From: Cyndi Tarapani <c.tarapani@tarapaniplanning.com>
Sent: Wednesday, March 26, 2025 12:43 PM
To: Michelle Miller
Cc: Omar DePablo; Danielle Nigro; KayMarie Griffith; Barbara Zellmer; Greg Stannard; Scott Stannard, P.E. (Scott.Stannard@gmcnetwork.com); Lam, Shelby; Bill Oliver, P.E.
Subject: Re: Maple Crossing
Attachments: Maple Crossing Narrative Revised 3-26-25.pdf; Maple Crossing Master Plan Rev 3-26-25.pdf; Oliver Ltr Trip Gen 3-11-25.pdf; Oliver Ltr Exhibit 3-11-25.pdf

**MAPLE CROSSING REZONING APPLICATION
PLANNED DEVELOPMENT NARRATIVE**

**August 6, 2024
Revised November 8, 2024
Revised November 22, 2024
Revised March 12, 2025**

MASTER SITE PLAN

Drawing No.:
PD-1.0

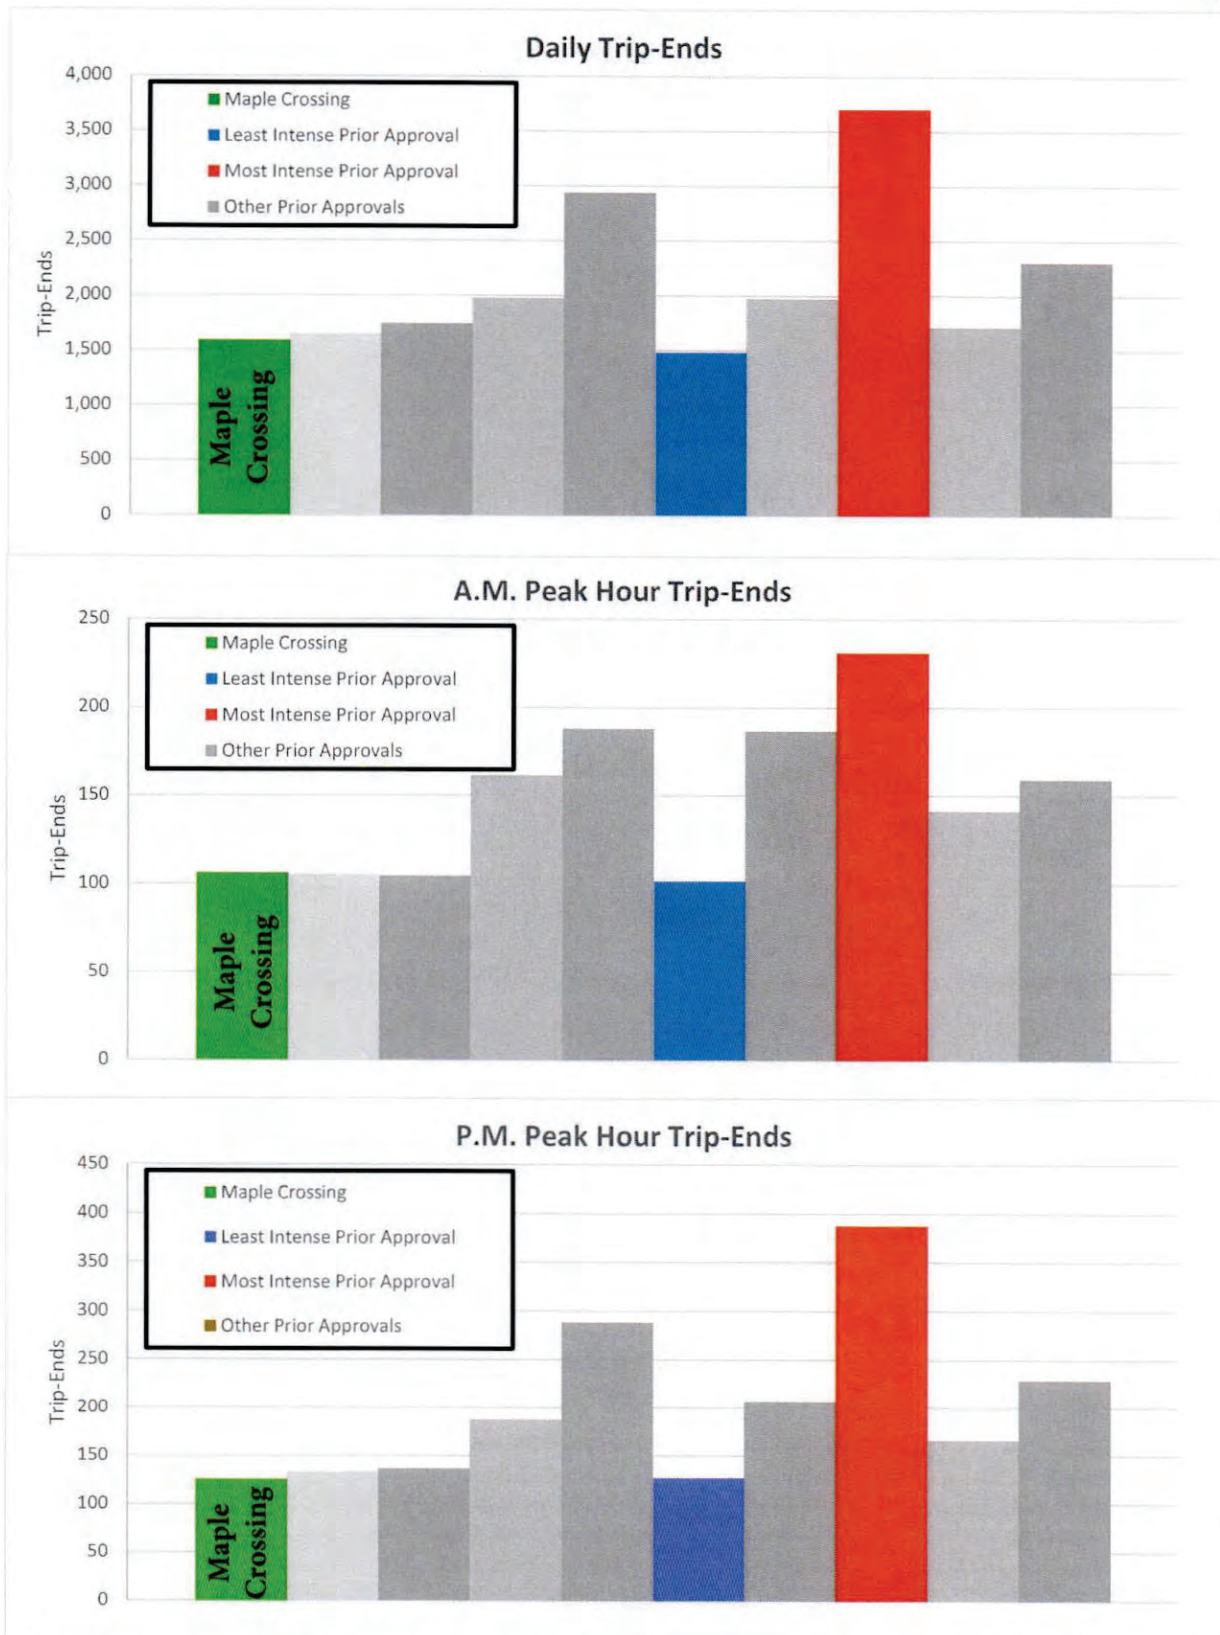
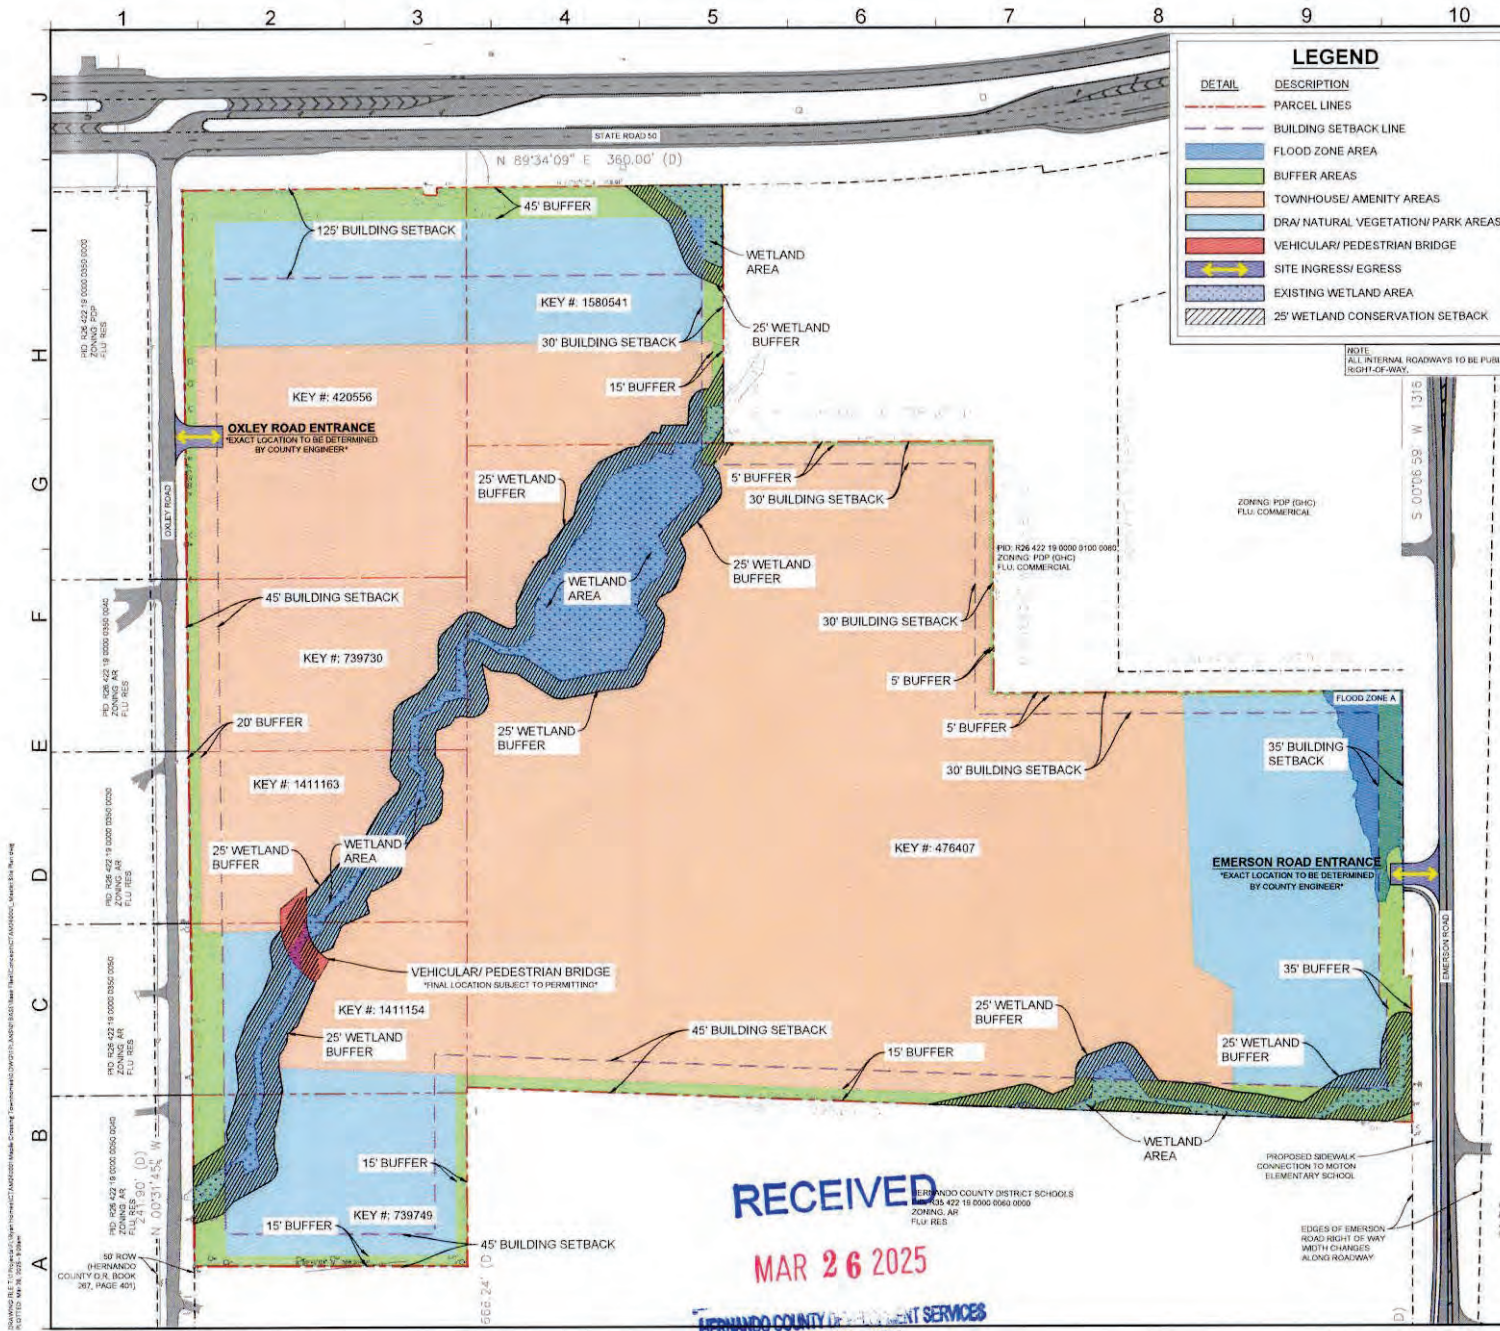
The Applicant has made significant changes to the project to address the comments and concerns raised by the Board at their January hearing. These changes are reflected on the attached Narrative and Master Plan and include the following items:

1. A significant reduction in the number of townhouse units from the original 245 units to the proposed 215 units.
2. A related reduction in density from the original 6.1 units/ acre to the proposed 5.4 units/ acre.

3. An improvement in the type and size of the proposed townhouse unit from the original 24' wide townhouse with a one-car garage to a 28' wide townhouse with a two-car garage. In addition, each townhouse will have a two-car driveway for a total of 4 parking spaces for each townhouse. We will present the new townhouse elevations at the public hearing.

4. Deletion of the request for a variance to the State Road 50 setback. The revised Master Plan now meets the 125' setback along State Road 50 as well as meeting all other setbacks. Therefore, there are only 2 deviations requested: to the lot size and to the internal front yard setback. A justification for each of these deviations is included in the Narrative.

5. Agreement to build a sidewalk on the west side of Emerson Road from the development's Emerson Road entrance to the vehicular driveway entrance to Moton Elementary School. We agreed to this condition at the January 28, 2025 BCC hearing
